**TOWN OF SUMMERVILLE
DESIGN REVIEW BOARD – AGENDA
Summerville Municipal Complex
Summerville Council Chambers or Zoom Virtual Meeting
September 17, 2020 4:00 p.m.**

Design Review Board Minutes
Thursday, August 20, 2020
Zoom Virtual Meeting

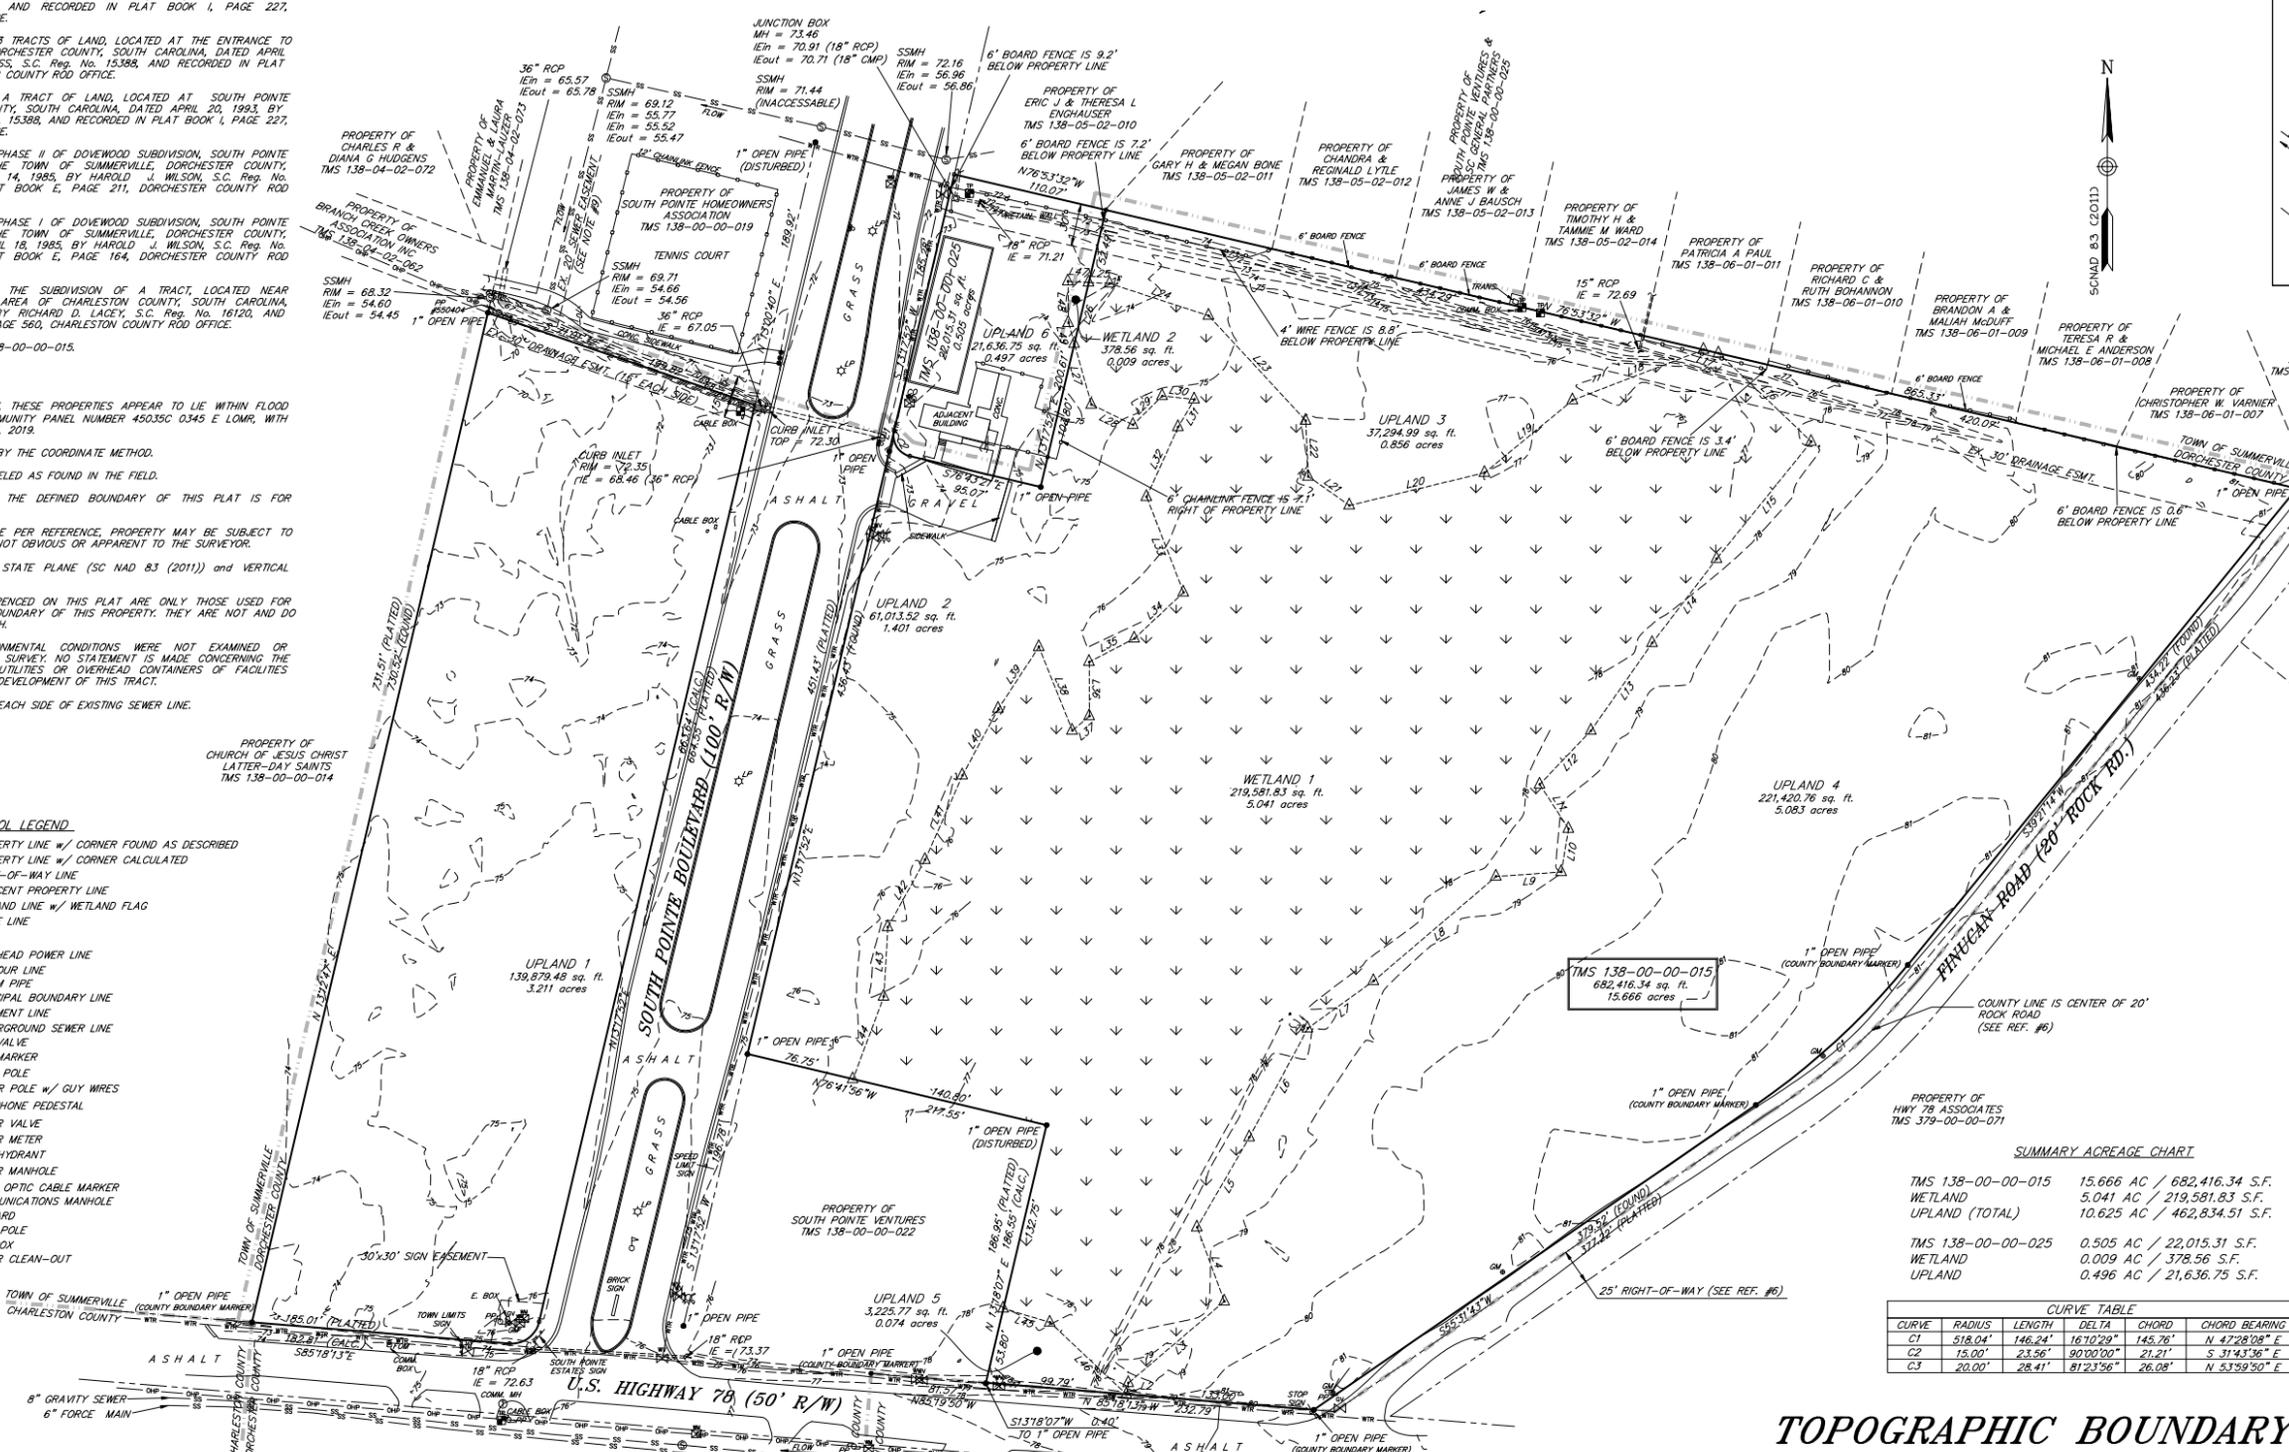
Based upon staff review the following comments must be addressed to meet requirements. The proposed 228 units is a mix of 1, 2, and 3 bedroom units. Coordination with Dan Ryan on the turn-lane right-of-way that is needed along the front of the property is required. Please show the required 25' wetland buffer, and the required calculations for the parks and open space on the site plan. A full grand tree (16" DBH or greater) survey will be required along with a ¼ acre representative sample of all trees 8" DBH or greater. Tree Protection Board approval will be needed. Parking does not exceed 200% of the minimum requirement. A Landscape Plan and Photo Metric plan are required. The materials for the building include a mix of fiber cement siding, both lap and board and baton. The main roofing material is asphalt shingles, with various roof elements over entrances utilizing standing seam metal. This mixture of materials meets the UDO requirements for façade materials. Color scheme and material boards will be required. Design and details of the proposed amenity center will be required.
